ADDENDUM No. 3

**ORG #207 – San Jacinto Elementary School - Renovation
ORG #273 – Pleasant Grove Elementary School – Renovation**

DALLAS INDEPENDENT SCHOOL DISTRICT

11/01/2024

3 MARQUEE SIGNAGE SECTION
 Scale: 1/2" = 1'-0"

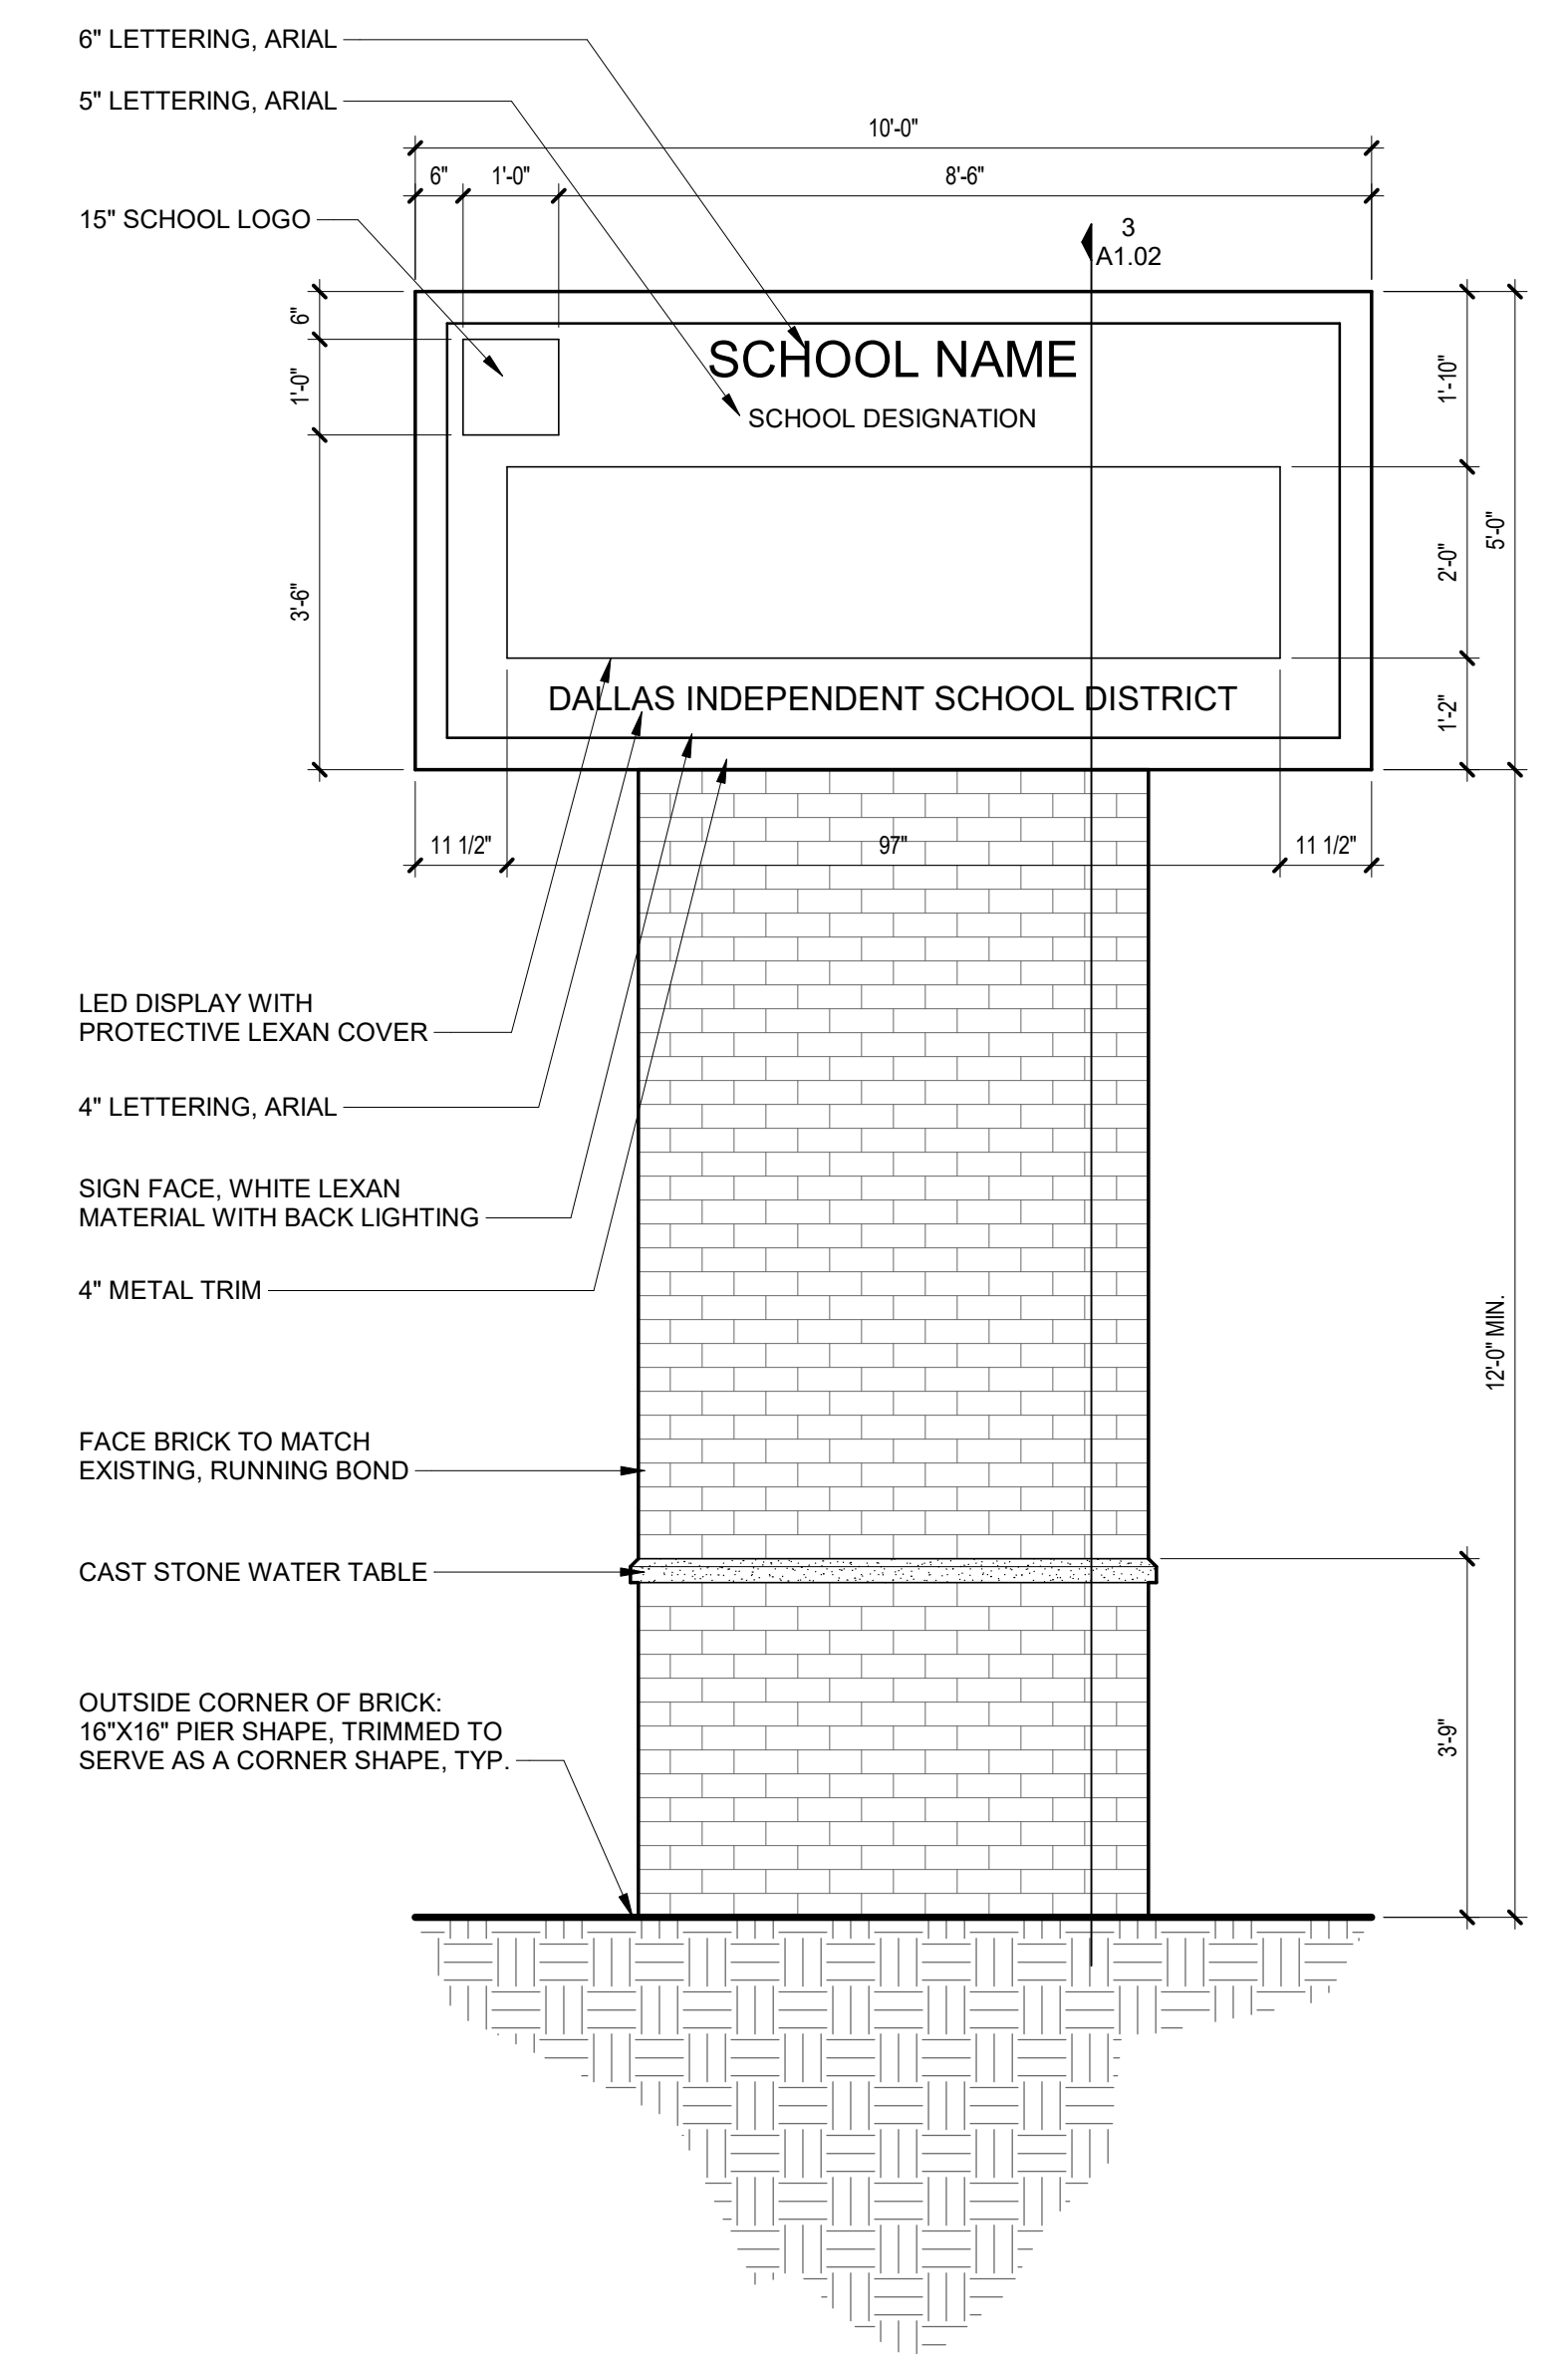
- Replace sheet with the revised attached A1.02.
 - Add note: Ensure UPN fiber running into building will not be affected by marquee excavation. If UPN fiber needs to be relocated, notify DISD.
- Replace sheet with the revised attached S2.01.
 - Add note: Ensure UPN fiber running into building will not be affected by marquee excavation. If UPN fiber needs to be relocated, notify DISD.
- Replace sheet with the revised attached R1 and R2
 - Add note: If there are adjustments to the existing roof openings or conflicts with the existing structure regarding roof top units, contact the Architect/EOR.

1. REFER TO MEP FOR ALL ELECTRICAL AND DATE REQUIREMENTS.
2. ENSURE UPN FIBER RUNNING INTO BUILDING WILL NOT BE AFFECTED BY MARQUEE EXCAVATION. IF UPN FIBER NEEDS TO BE RELOCATED, NOTIFY DISD.
